Review: Annual Report

RE: Review 2024 Annual Report Thompson Resources/Horn Gravel Pit Permit M1983102

Barrow (Permit [REDACTED]) Access Road
 area on Northern Water property in Grand County

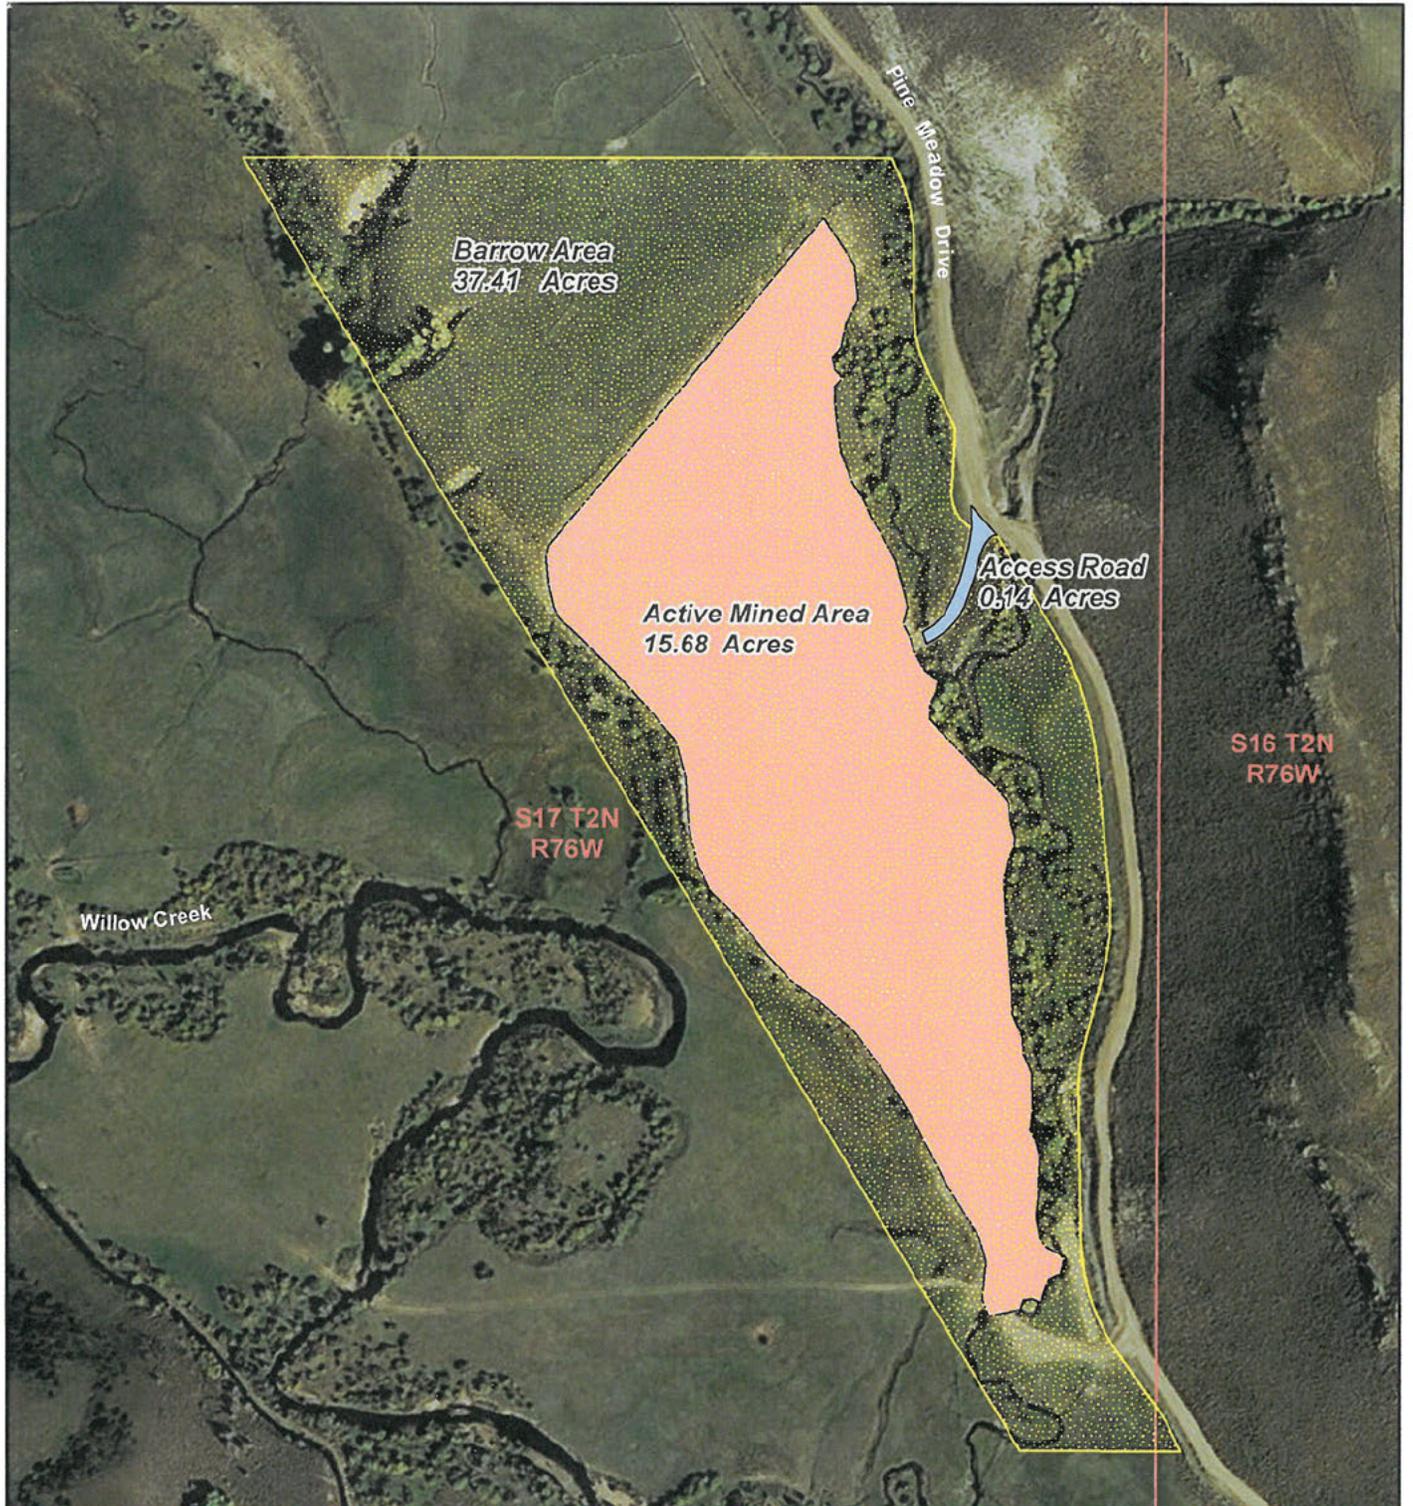
The 2024 annual report map is inadequate.

1. Please explain the discrepancies in affected areas and provide supporting documentation.
2. For the 2025 annual report map please use Rule 1.15 as a guide and include:
 - A google earth background image
 - A north arrow
 - A distance scale
 - Access road
 - CO or State Highway with labels
 - Section, Township and Range lines and labels
 - Rivers and streams
 - A legend indicating the following polygons
 - ✓ Affected area
 - ✓ Active Mining
 - ✓ Permit area
 - ✓ Reclaimed areas
 - ✓ Topsoil piles

As per the example included.
